Objection to planning application 2019/5835/P - 4B Hampstead Hill Gardens

Current street view: 4A is the red brick house centre and right, with the sloping roof, 4B is the small metal-clad structure to the left. (Image source: Google street view, accessed Feb 10, 2020)

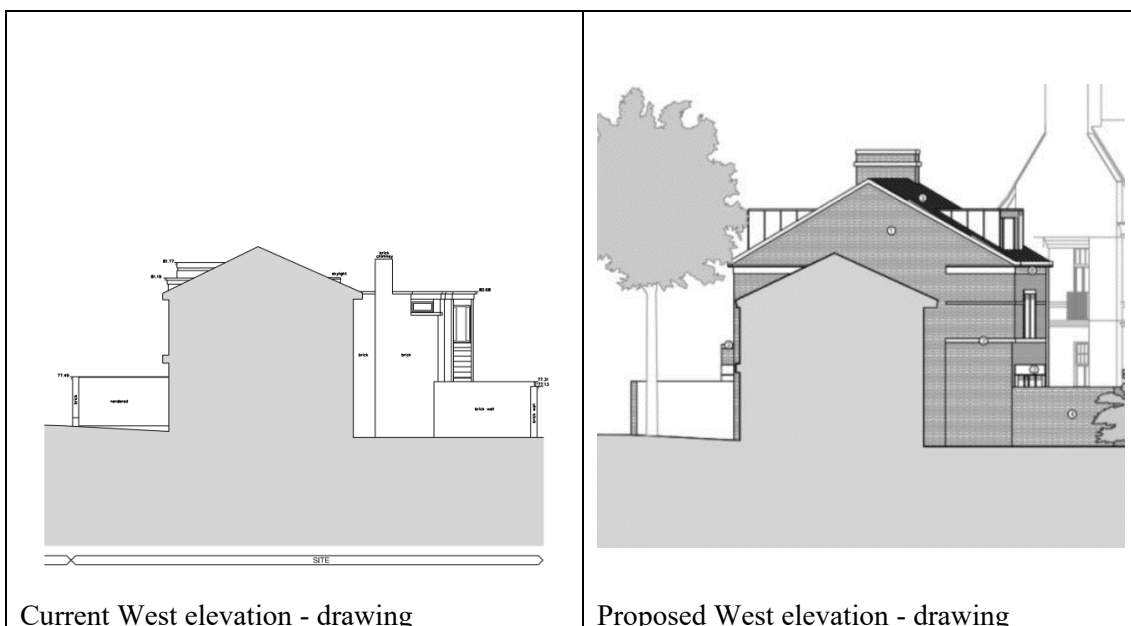
This image clearly shows that 4B is lower in height than 4A, and is subordinate in size and visually to 4A. Any acceptable redevelopment of 4B must result in a structure not exceeding the height of 4A, with complementary building lines and design features. Such a redesign could no doubt greatly improve the current appearance of 4B, and would be likely to receive a more sympathetic response from neighbours and heritage groups.
